Metropolitan Coal Mine - Longwalls 305-307 Extraction Plan

METROPOLITAN COAL MINE LONGWALLS 305-307 EXTRACTION PLAN Reasons for Approval

**Re: Advice to the Department of Planning, Industry and Environment
IEPMC 2020-01: Metropolitan Coal Mine Longwalls 305-307 Extraction Plan**

Figure 1: Zones within which higher frequency monitoring is proposed

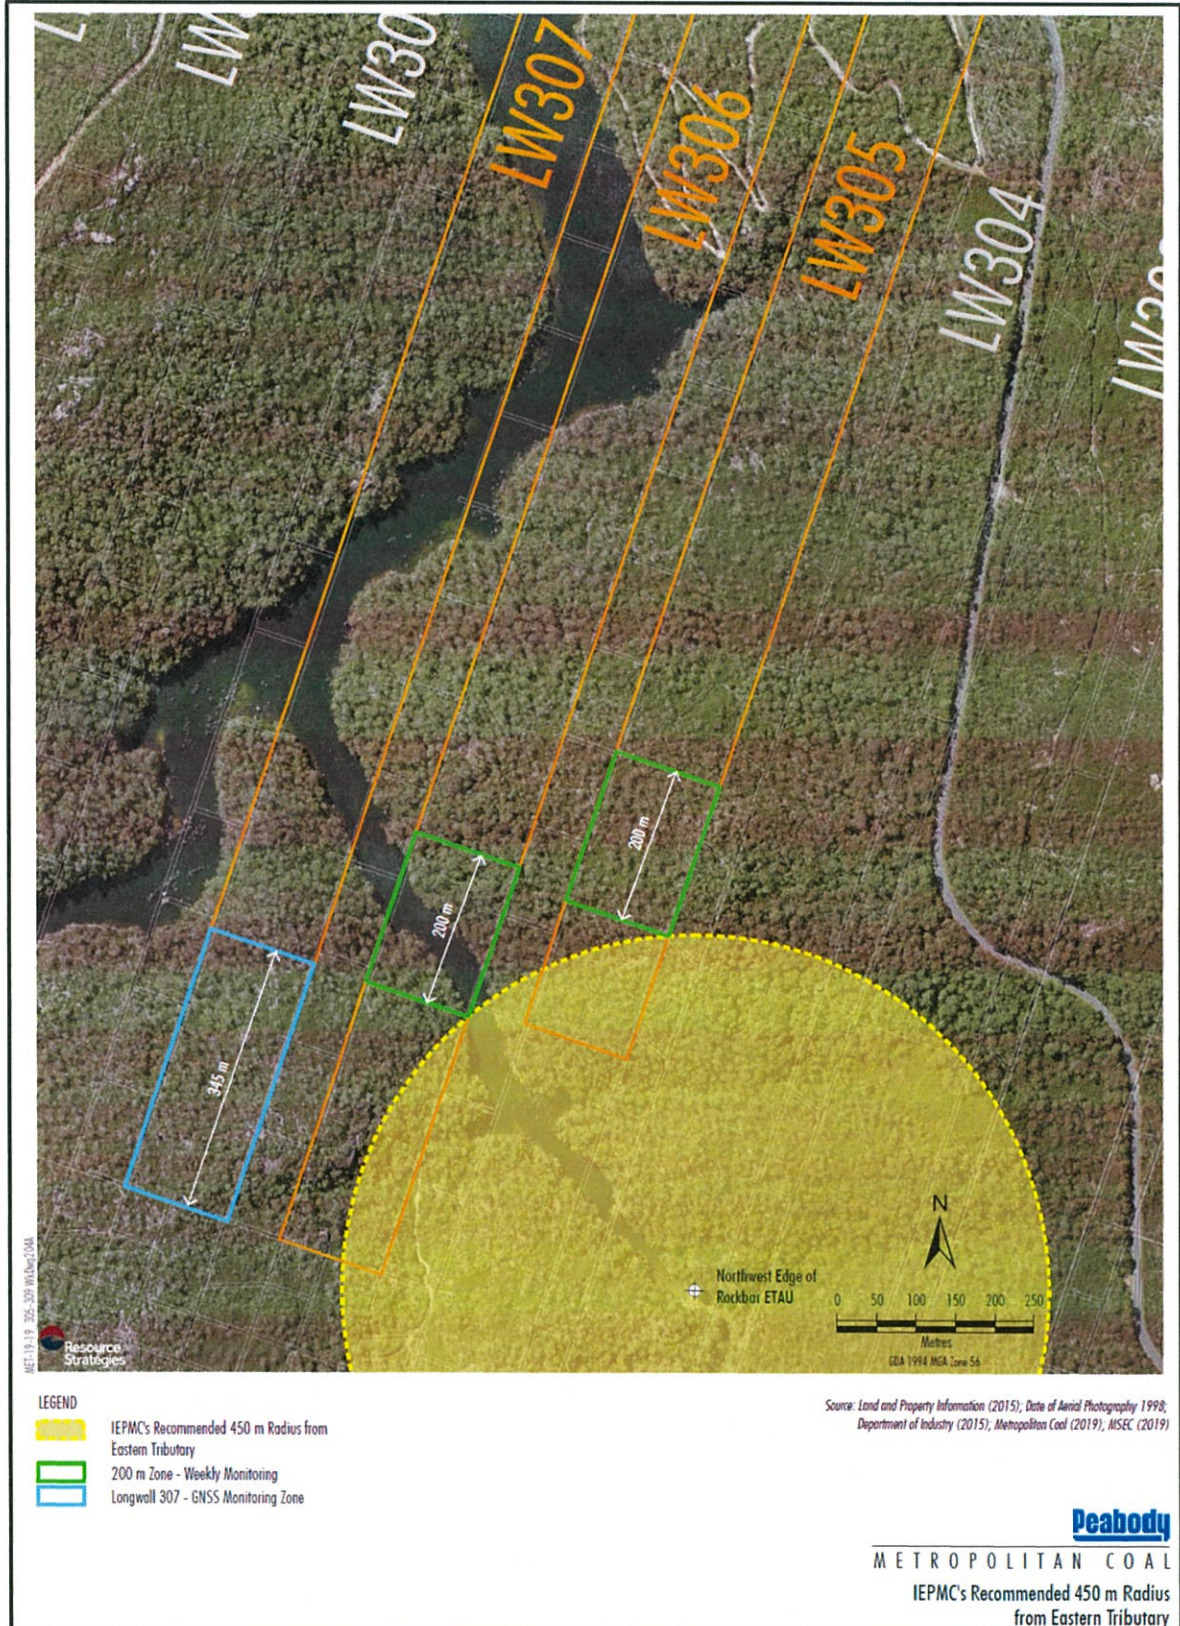
- The Department notes that the Trigger Action Response Plan for Eastern Tributary has been designed (similar to the one implemented for Longwall 304) to include higher frequency monitoring as the finishing lines of the panels are approached, as requested by WaterNSW and as recommended by the Catchment Panel and WRIS Panel. The zones in which the higher frequency monitoring would be undertaken are shown in Figure 1, which is attached to this document.

- However, as for previous longwall panels, the Department considers that higher frequency monitoring should be required as Longwalls 305 and 306 are within 200 m of the Catchment Panel's previously recommended 450 m radius from the Eastern Tributary, and within 345 m of the finish line of Longwall 307 (as shown in Figure 1 attached to this document).
